LaMarche Creek Ranch
Environmental Assessment
Final Draft

5.0 RESPONSE TO COMMENT LETTERS

Anderson Engineering's responses are typed in blue and the comments are italicized. For complete comments please see the previous section.

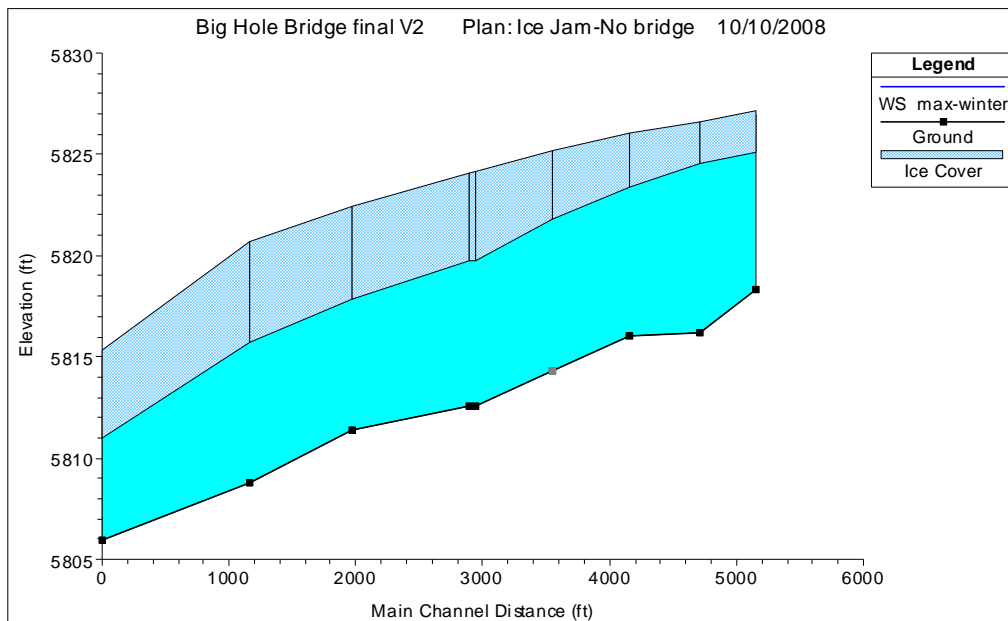
1. *"While the bridge does span the high water mark, there is still, in my opinion, significant risk of substantially altering the hydrology of the river at this location, which may cause impacts to the fisheries habitat and potentially increased erosion."* The hydrology of the river will not be affected; however the hydraulics of the river will be minimally affected by the proposed bridge. The change in river water velocity and elevation was calculated using HEC-RAS modeling software. The maximum change in water surface elevation on the main river channel is 0.07 ft. and the maximum change in water velocity is 0.07 ft/s during the 100-year storm event. A maximum change in water surface elevation of 0.5 ft. is permitted by both counties floodplain regulations (Chapter V.B.2). The change in water surface elevation due to the construction of a bridge over the Big Hole River is just over a tenth of the allowable amount. These changes occur during the 100-year storm and will be less during normal conditions. The proposed bridge location is stable and has not migrated or eroded noticeably in the last fifty years as shown in the following aerial photos.

After Bridge Construction

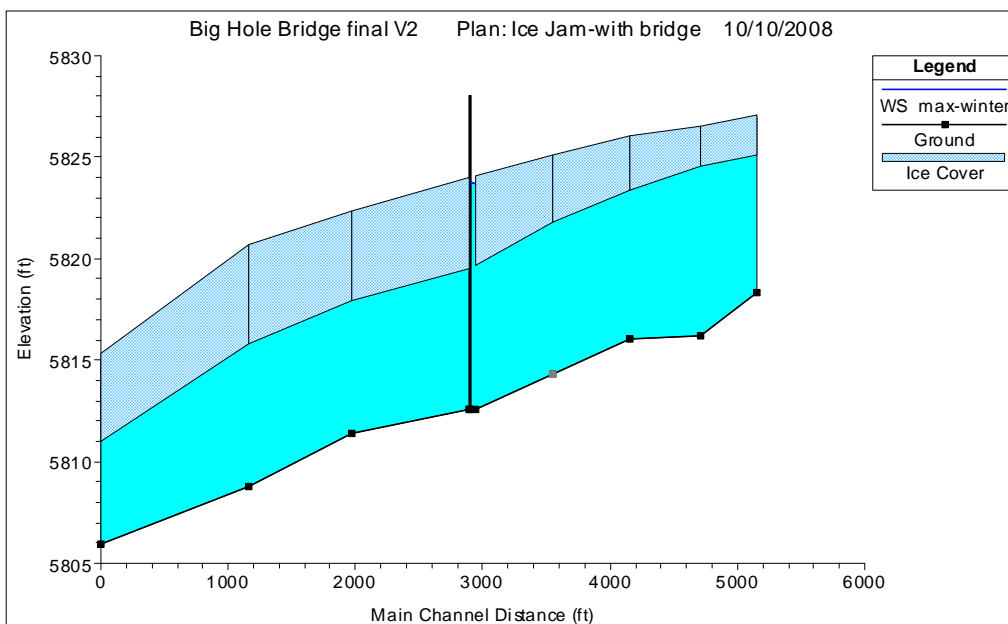
2. *“My main concern is with the potential of ice jams at the location and the impacts ice jams may have as a result of blocking significant portions of the floodplain with road fill and bridge abutments where flood and ice flows would likely move through.”* The ice jam effect was modeled using HEC-RAS at the bridge location. The profile windows on the next page, produced by HEC-RAS, show the ice jam event before and after the construction of the bridge, respectively. Real time data from the USGS website was used to model the flows. The gage site at Melrose, Montana has been monitored since the winter of 1923 and the website provides a table with the monthly flow rates from then until now. Assuming the “winter” months are October thru April the highest recorded flow value is 3515 cfs in April of 1943. This value was used to model the ice jamming event even though Melrose is downstream of the proposed bridge location and has noticeably higher flows, to provide a conservative analysis. The ice jam occurs naturally with or without the bridge due to a change in grade of the river bed. The ice and water will still be able to move over the remaining floodplain since the road will be built at-grade and allow water and ice to move over it during flooding and/or ice jam events.

Figure 2: 374 foot Cable Stayed Bridge

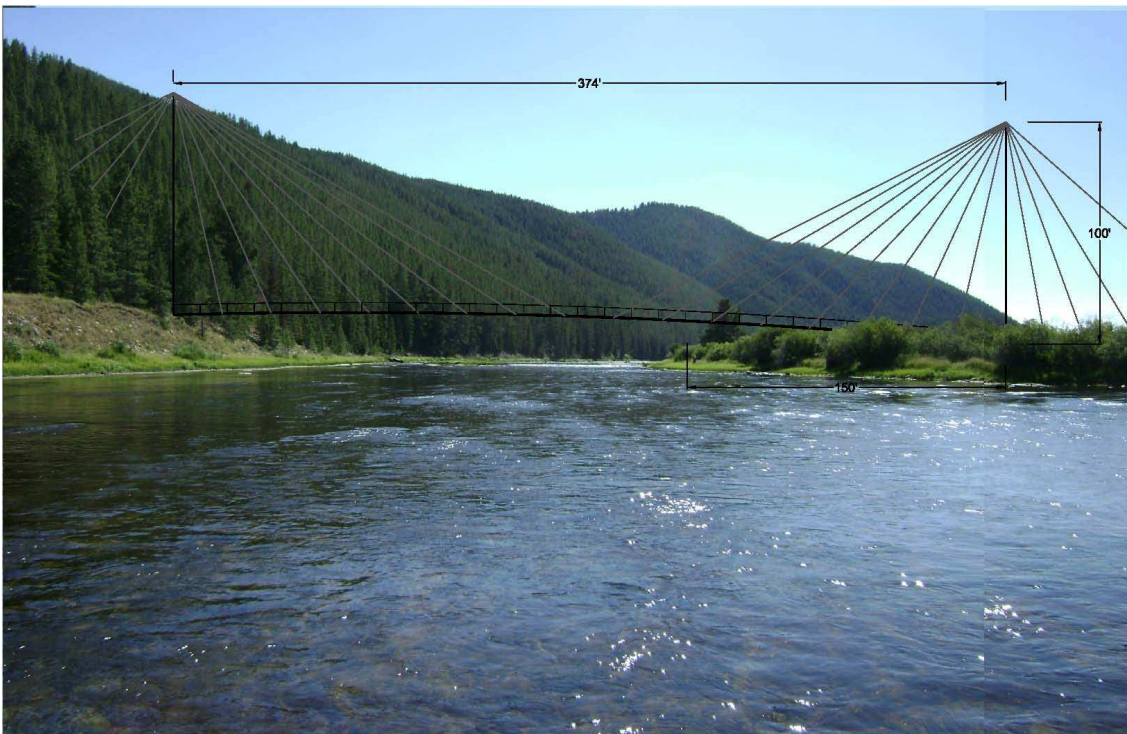
Complying with this set back would increase the length of the bridge from 220 feet to 374 feet; figures 1 and 2 show computer renderings of the two bridges respectively. The number of cables needed to hold the bridge would increase and the towers for the bridge would also increase in height from 40 feet to 100 feet.
